VALUE ENGINEERING STUDY

Project # STP00-2009-00(004) PI No. 742870-
SR 920 from SR 54/Fayette to SR 3/US 19/Clayton
Fayette/Clayton County, Georgia

16 May 2013

**Flint River Bridge
Short Spans on Pile Bents**

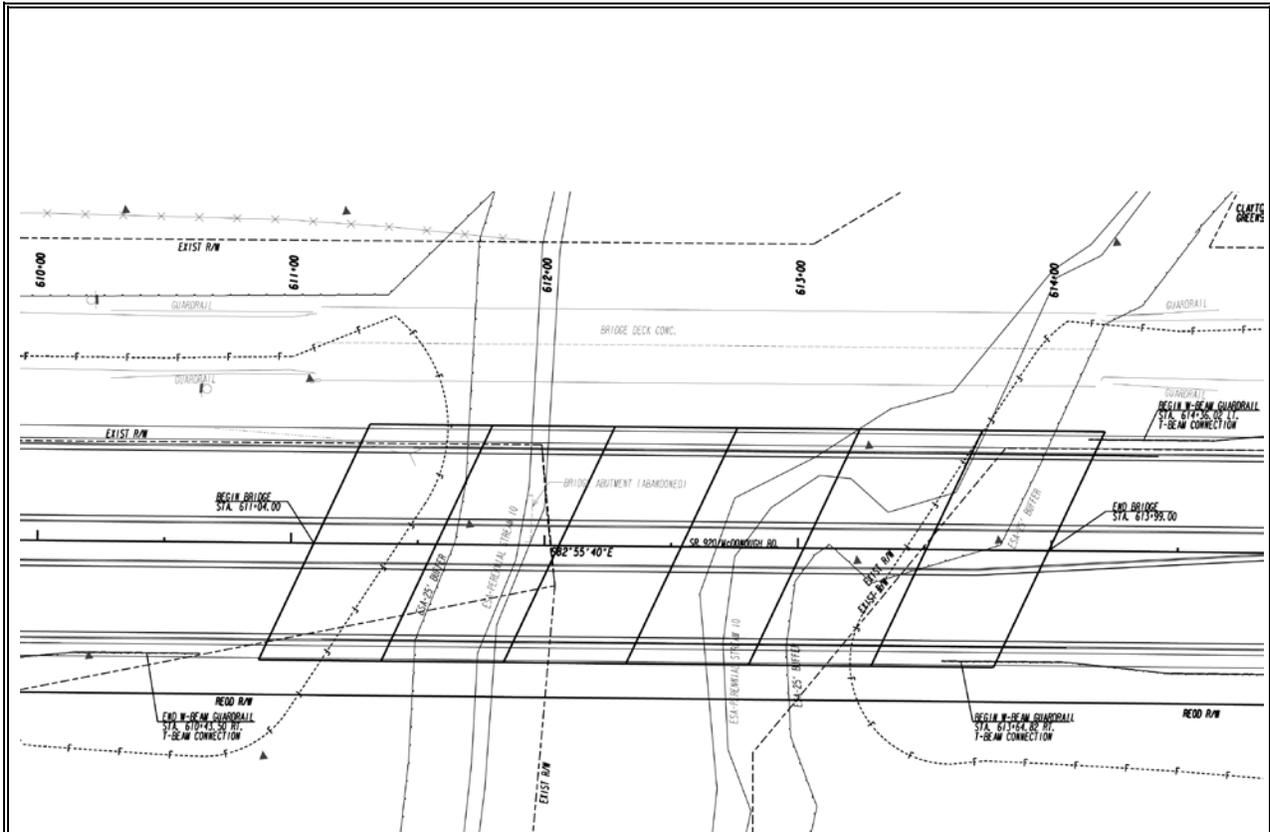
PROPOSED CHANGE: It is proposed to use short spans on pile bent foundations. The proposed bridge is 290' long by 93'-6" and consists of 6 – 48'-4" Type 2 PSC beam spans. The reduction in beam depth will also allow for the profile to be lowered by approximately 2.75 ft.

Hurricane Creek Bridges
Long Spans on Concrete Bents

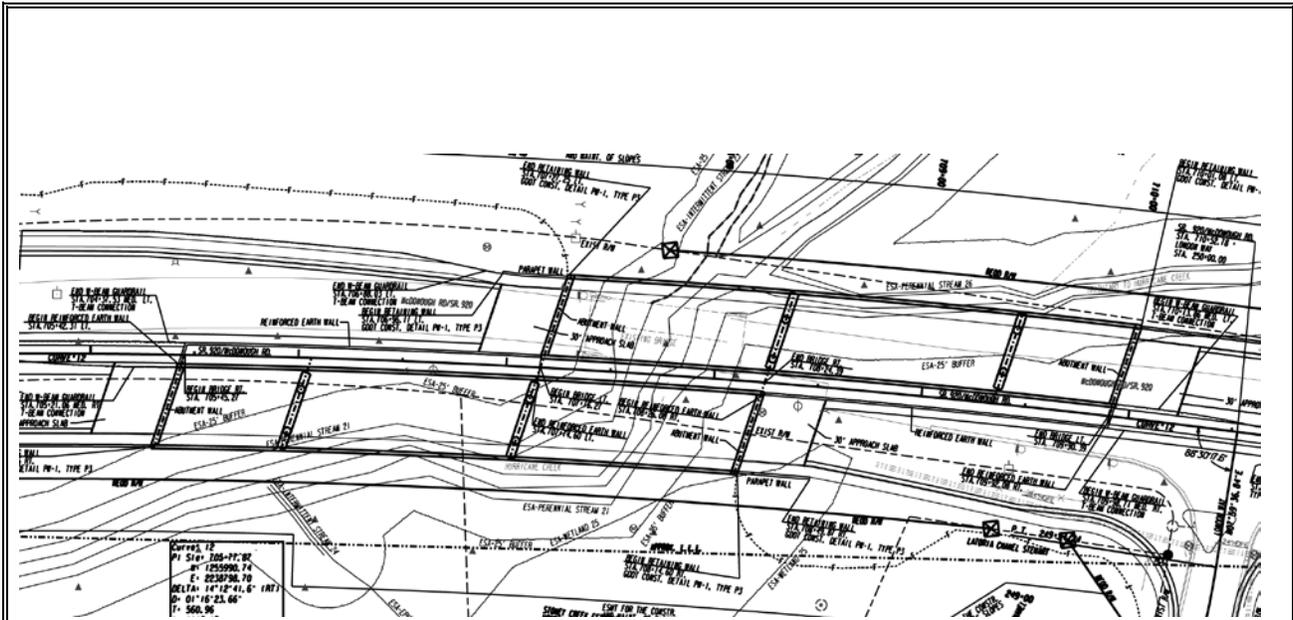
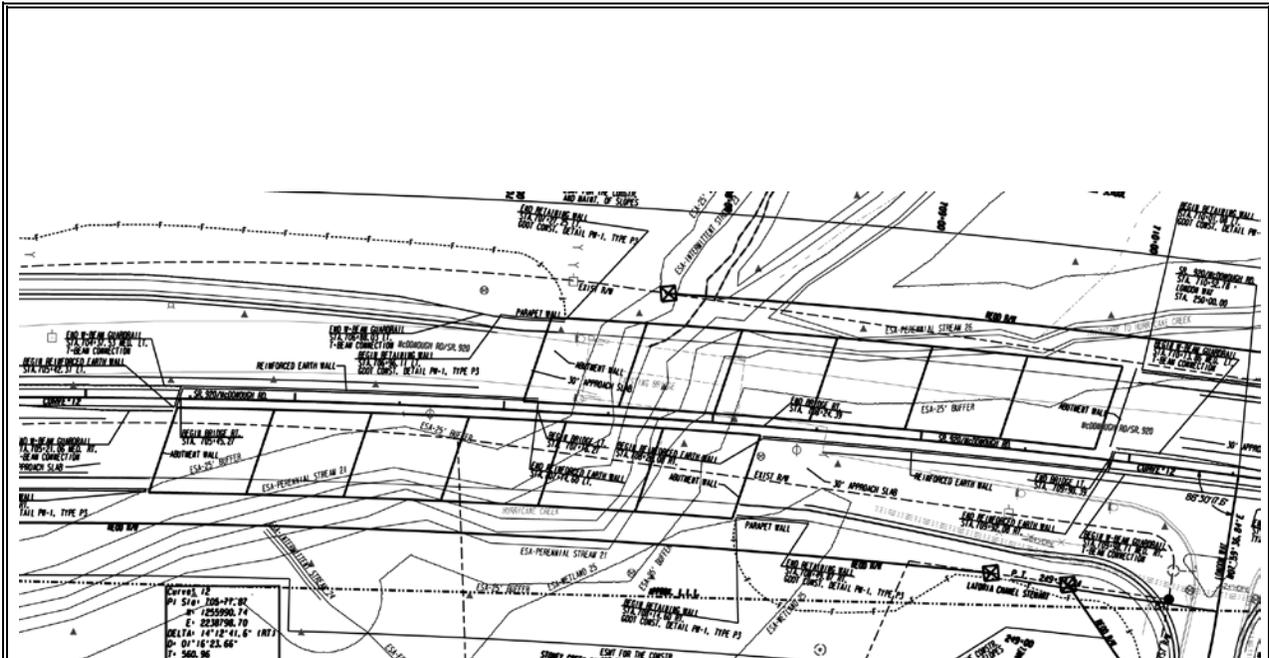
PROPOSED CHANGE: It is proposed to use short spans on pile bent foundations. The proposed bridges will consist of 6 equal Type II PSC beam spans. The right bridge will be 281' long by 40'-9" wide with 46'-10" spans and the left bridge 276' long by 40'-9" wide with 46'-0" spans. The reduction in beam depth will also allow for the profile to be lowered by approximately 1.5 ft.

PROPOSAL NUMBER: B-4.0 **PAGE NUMBER:** 3 of 4

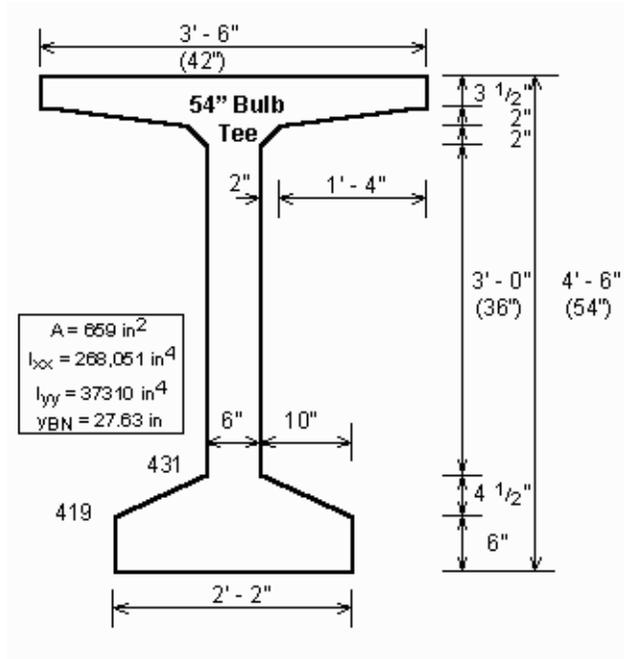
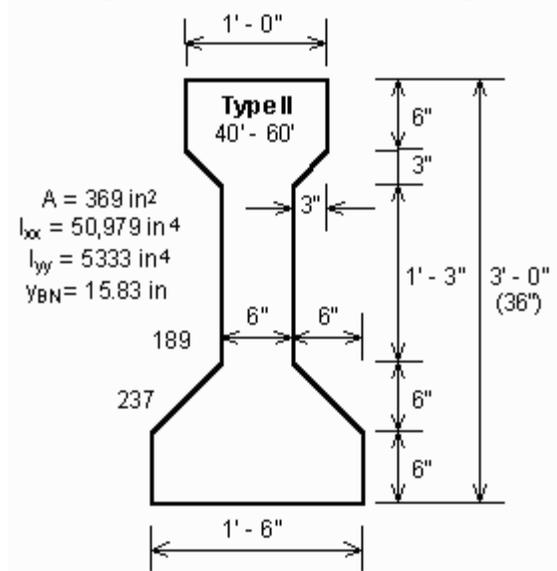
PROPOSED CHANGE: It is proposed to use smaller Type II PSC beams for the shorter spans on these bridges. These spans are span 1 of the right bridge (61’) and span 3 of the left bridge (56’).

PROPOSAL NUMBER: R-1.0

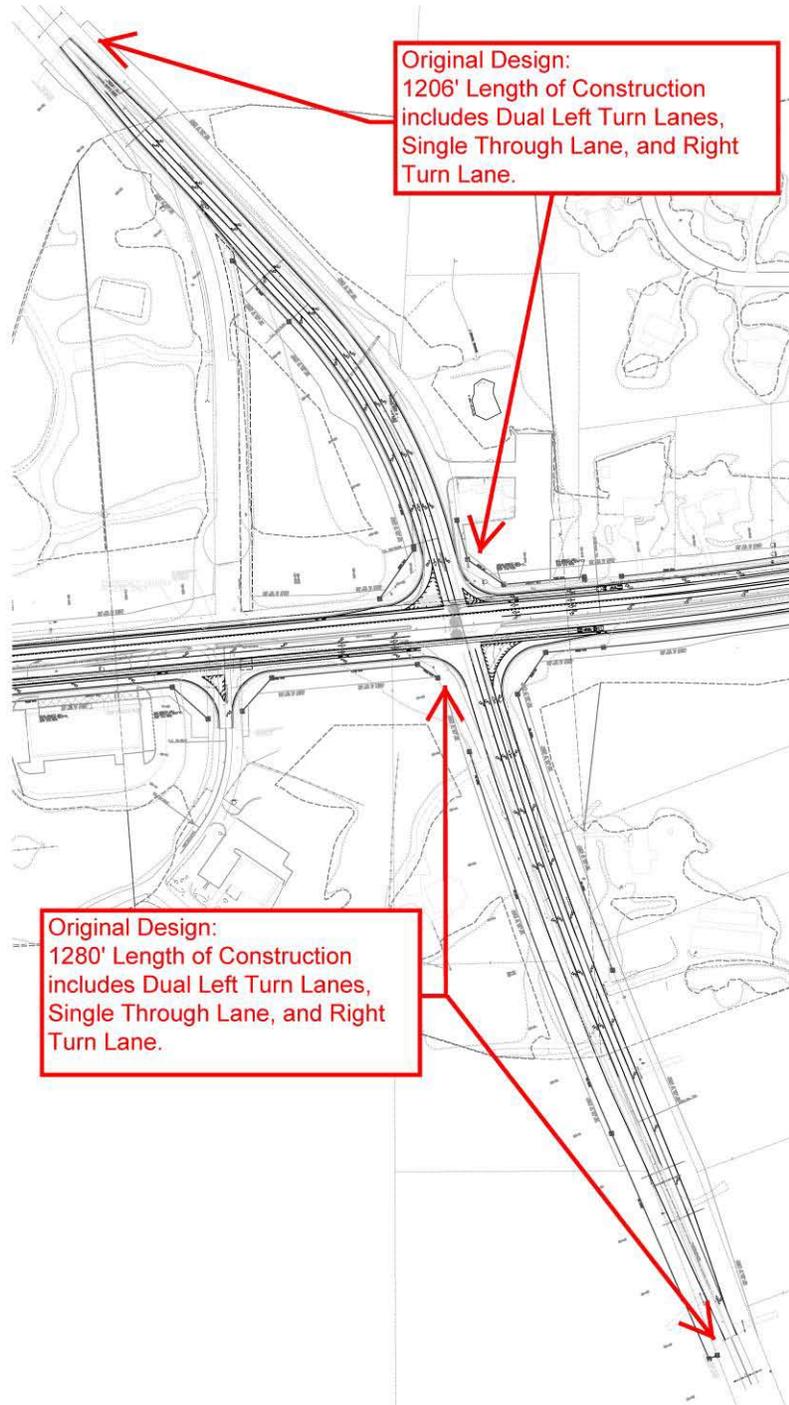
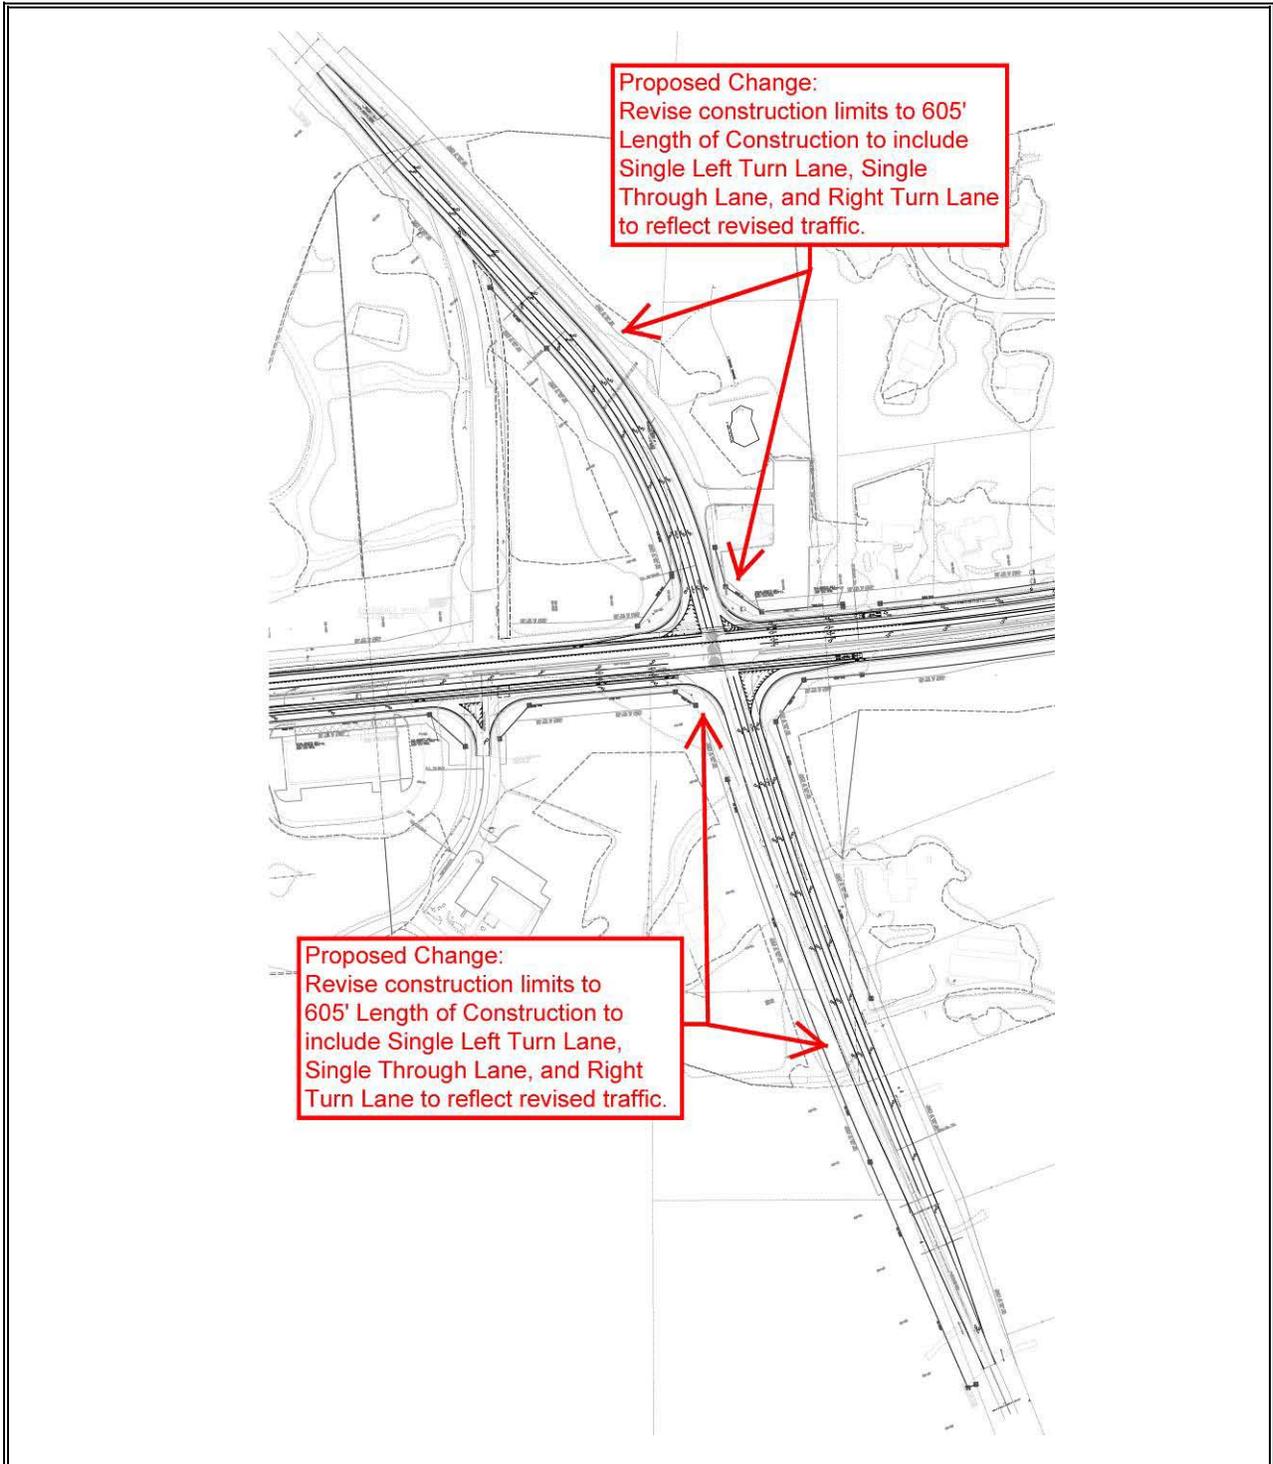
PROPOSED CHANGE: The approved traffic for the proposed East Fayetteville Bypass indicates that a large percentage of traffic will continue North along the bypass alignment to access SR 920/McDonough Road and SR 54 to the North, thereby shifting traffic off of County Line Road and McElroy Road between the bypass alignment and SR 54. As a result of this reduced traffic volume due to the East Fayetteville Bypass construction, the lane assignments required for the Build condition would be a single left turn lane, a single through lane, and a single right turn lane on County Line Road and McElroy Road. The turning volumes in the AM and PM peak would be low enough that the minimum right and left turn lane storage lengths as suggested in the GDOT Driveway and Encroachment Manual should be sufficient.

PROPOSAL NUMBER: R-2.0

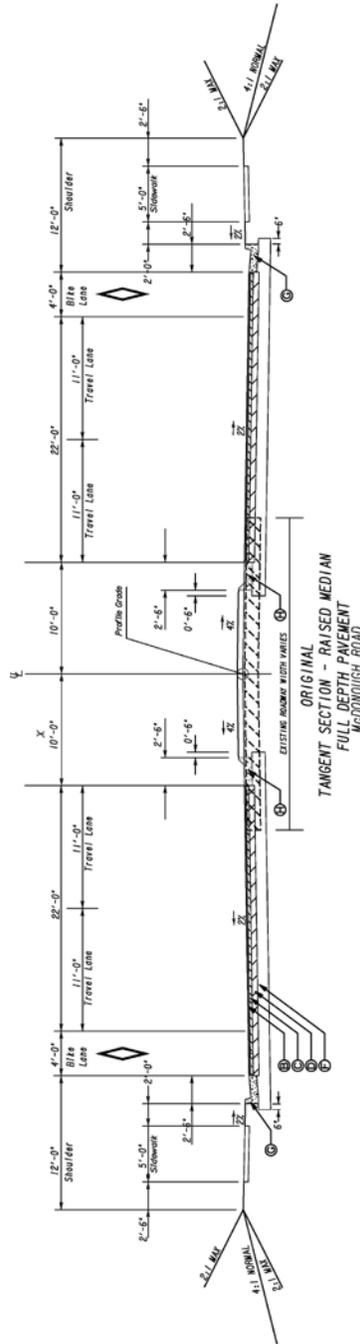
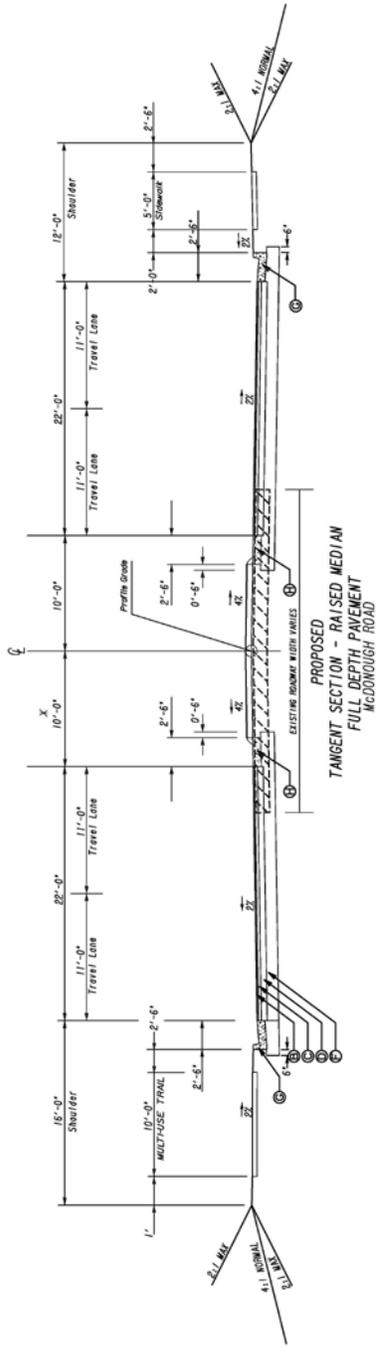
PROPOSED CHANGE: It is proposed to include a 10-foot wide multi-use trail on one side of SR 920 and a 5-foot sidewalk on the opposite side. The SR 920 corridor is on a statewide bike plan. The multi-use trail would be located on the North side of SR 920 from the beginning of the project where the park and schools are located to Panhandle Road where it would crossover to the South side of SR 920. From Panhandle Road to the end of the project the trail would remain on the South side of SR 920 where the high school and Lovejoy Park could be accessed. Pedestrian access would be provided by the 5-foot sidewalk on the opposite side of the road from the trail and cross access would be provided at signalized intersections.
